United States Patent and Trademark Office

APPLICATION NO.	FILING DATE	FIRST NAMED INVENTOR	ATTORNEY DOCKET NO.	CONFIRMATION NO
09/531,735	03/21/2000	Shalom Levin	EPLC/03	7129
75	90 04/21/2003			
Jerome R. Smith Holland & Knight LLP One Atlantic Center			EXAMINER	
			KOVACS, ARPAD F	
1201 West Peachtree St. NE Suite 2000 Atlanta, GA 30309-3400			ART UNIT	PAPER NUMBER
			3671	· ·
			DATE MAILED: 04/21/2003

٥.	Application No.	Applicant(s)				
Office Action Summary	09/531,735	LEVIN ET AL.				
Office Action Summary	Examiner	Art Unit				
The MAILING DATE AND	Árpád Fábián Kovács	3671				
The MAILING DATE of this communication app Period f r Reply	ears on the cover sheet with the	correspondence address				
A SHORTENED STATUTORY PERIOD FOR REPLY IS SET TO EXPIRE 3 MONTH(S) FROM THE MAILING DATE OF THIS COMMUNICATION. Extensions of time may be available under the provisions of 37 CFR 1.136(a). In no event, however, may a reply be timely filed after SIX (6) MONTHS from the mailing date of this communication. If the period for reply specified above is less than thirty (30) days, a reply within the statutory minimum of thirty (30) days will be considered timely. If NO period for reply is spec

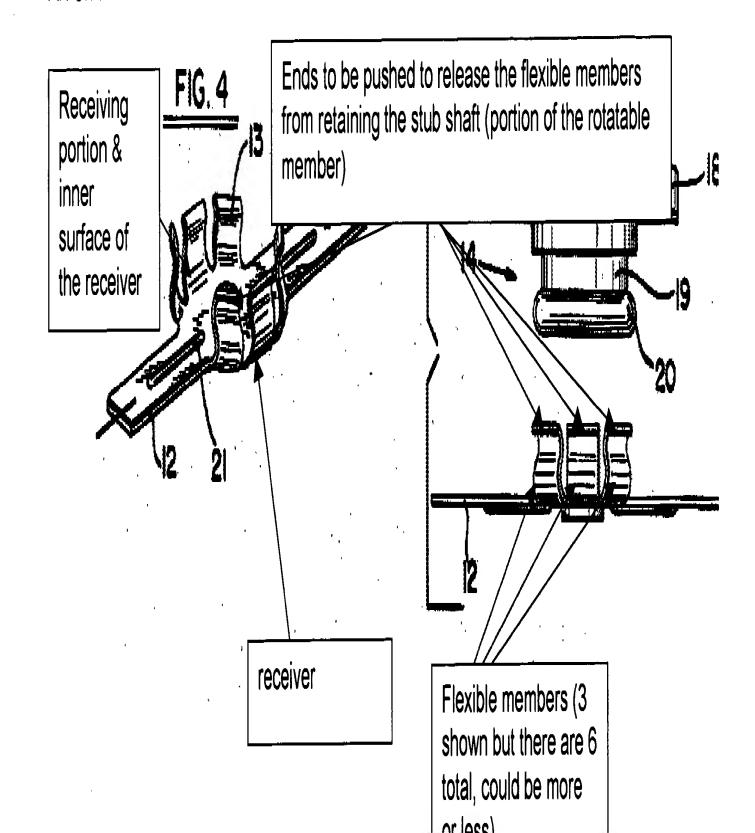
In response to applicant's argument that Weber's spring clips are strips that move outward as a whole, thus fails to show the claimed invention, the fact that applicant has recognized another advantage which would flow naturally from following the suggestion of the prior art cannot be the basis for patentability when the differences would otherwise be obvious. See *Ex parte Obiaya*, 227 USPQ 58, 60 (Bd. Pat. App. & Inter. 1985).

In response to applicant's argument that Weber's clips hold the hub (stub shaft), that there is not motivation to add additional structure etc..., is not agreed with, since the Examiner is not suggesting adding any structure. As Weber shows it meets the claimed limitations. Although in the rejection above the claimed limitations are clearly addressed, the Applicant will show with arrows the portions considered:
